AIR - HP COMPRESSOR STAGE 7 AND STAGE 10 BLEED VALVES - INTRODUCTION OF AN IMPROVED  
CENTER BUSH - 4 - MOD.ENG-75-0040

V2500-ENG-75-0040

**Introduction of Improved Material Bush on HP7 and HP10 Bleed Valves  
DUNLOP MODIFICATION E586 (HP7 Bleed Valve) and E587(HP10 Bleed Valve)**

**Figure 1 Pre and Post Mod Configuration**

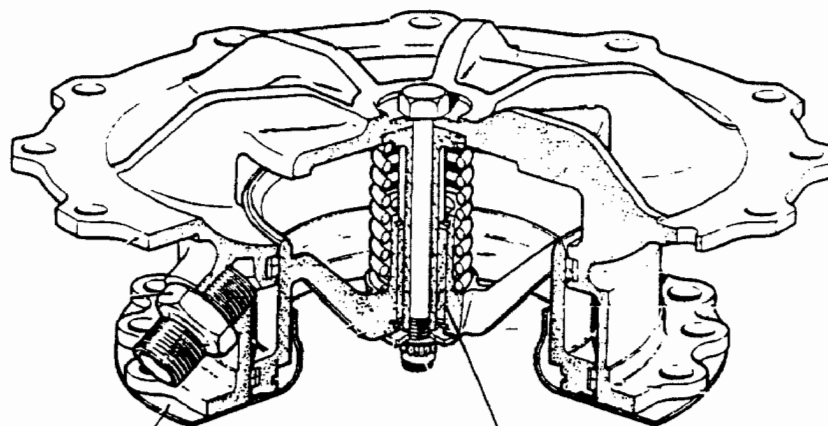
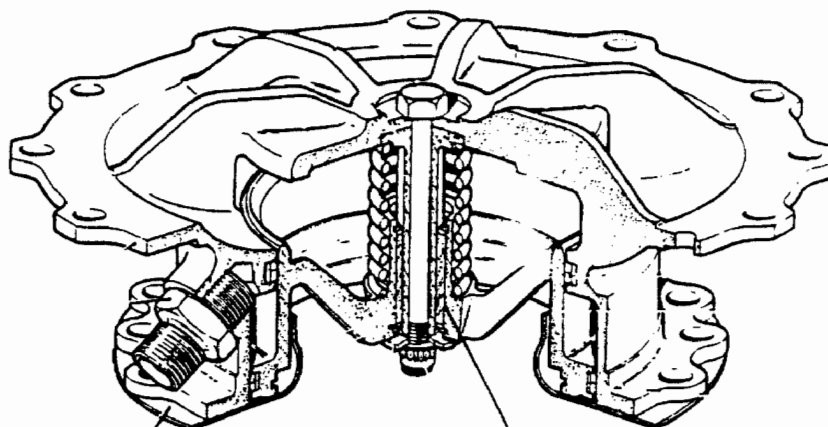
The reason for the problem is the presence of water affecting the existing carbon bush material.

- (1) The procedures introduced by this Service Bulletin are as follows:-
  - Disassembly of HP7 & HP10 Bleed Valves
  - Re-work of valve stem ACO45615
  - Replacement of Triple Seal Assembly DAS2485-1256
  - Replacement of Triple Seal Assembly DAS2505-1225
  - Introduction of modified Bush ACO47056 in lieu of ACO45618
  - Replacement of Nut AS20625
  - Replacement of Rivet AS46791-411 (HP10 Bleed Valve only)
  - Assembly of modified Bleed Valves
  - Re-identification of Bleed Valves
- (2) Refer to figure 1 for pre and post mod configuration of the bleed valves

Shroud (HP10 Bleed Valve Only)      Split Bush PN ACO45618  
HP7 Bleed Valve Pre Mod E586  
HP 10 Bleed Valve Pre Mod E587

Shroud (HP10 Bleed Valve Only)      Split Bush PN ACO47056  
HP7 Bleed Valve Post Mod E586  
HP 10 Bleed Valve Post Mod E587

Figure 2 Exploded View of Bleed Valve showing Mod/Rework Kit Items

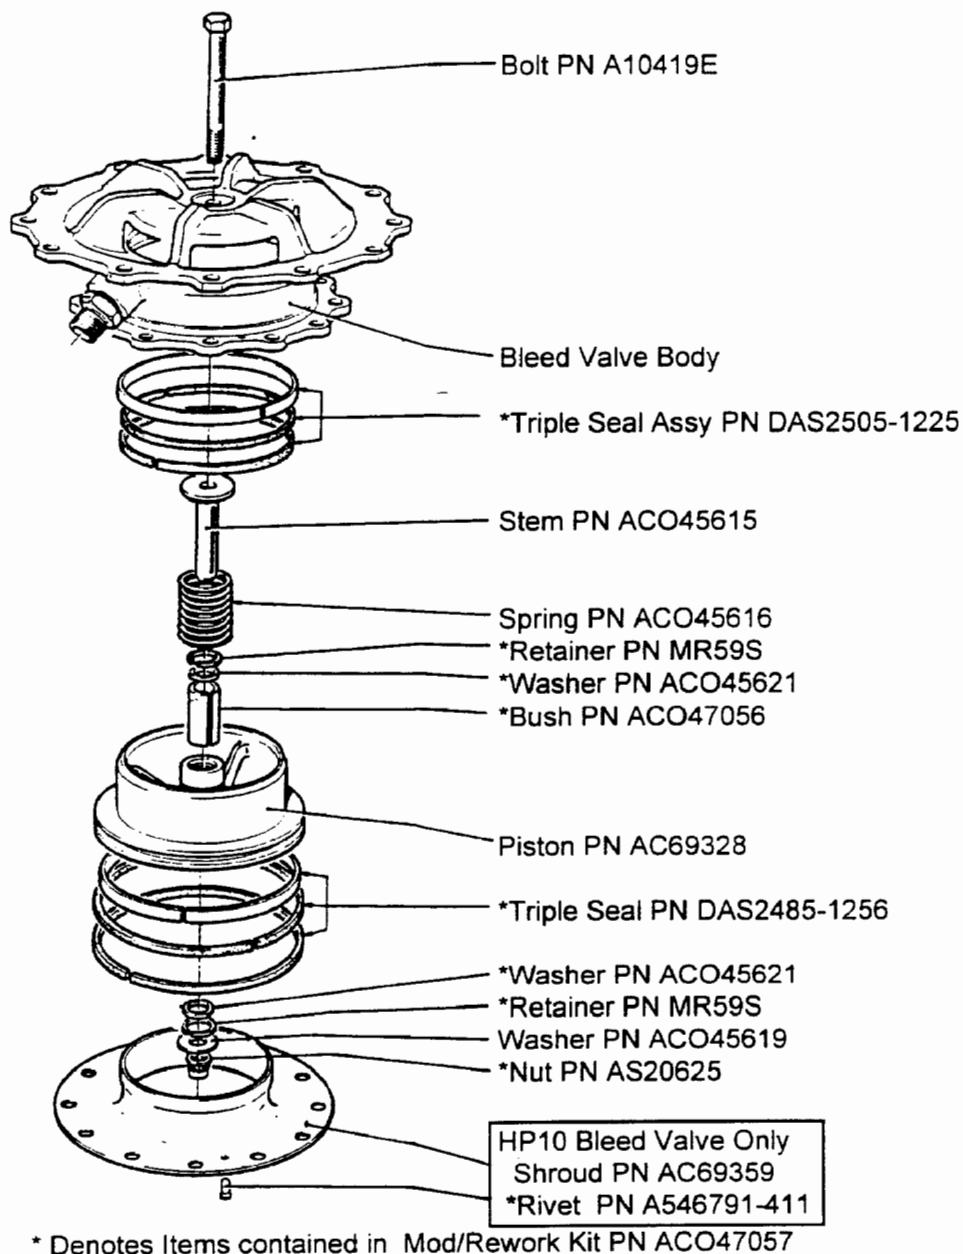
### A. Modification Instructions (Refer to Figure 2)

- (b) Using the Britool A70, AB312 and AB437 Tools remove the PN  
AS20625 Nut, the PN ACO45619 Washer and the PN A10419E Bolt.  
Discard the PN AS20625 Nut.
- (c) Remove the PN AC69328 Piston, the PN ACO45615 Valve Stem  
and PN ACO45616 Spring.
- (d) Remove the PN DAS2485-1256 Triple Seal Assembly from the  
Piston.  
Discard the PN DAS2485-1256 triple Seal Assembly
- (e) Remove the (two off) PN MR59S Retainers, the (two off) PN  
ACO45621 Washers and the PN ACO45618 Bush from the Piston.  
Discard the PN MR59S Retainers, PN ACO45621 Washers and the  
PN ACO45618 Bush.
- (f) Remove the PN DAS2505-1225 Triple Seal Assembly from the Bleed  
Valve Body.  
Discard the PN DAS2505-1225 Triple Seal Assembly

#### **B Fitment Instructions (Refer to Figure 2)**

- (b) Install a new PN DAS2505-1225 Triple Seal Assembly in the Bleed Valve Body. Make sure the ring gaps are equispaced around the circumference.
- (c) Install one of the new PN MR59S Retainers, one of the new PN ACO45621 Washers and the MODIFIED PN ACO47056 BUSH in the Piston.

- (d) Install a second new PN MR59S Retainer and a second new PN ACO45621 Washer in the Piston.
- (e) Install a new PN DAS2485-1256 Triple Seal Assembly on the PN AC69328 Piston. Make sure the ring gaps are equispaced around the circumference.

- (f) Install the PN A10419E Bolt through the Body. Install the PN ACO45615 Valve Stem over the Bolt and locate the Valve Stem flange in the recess in the Body

- (k) Using the Acratork Model A, Britool AB312 and AB437 Tools torque tighten the PN AS20625 Nut to 8,5/9,0 Nm (75/80 lbf in.) plus the torque required to overcome the lock properties of the Nut.
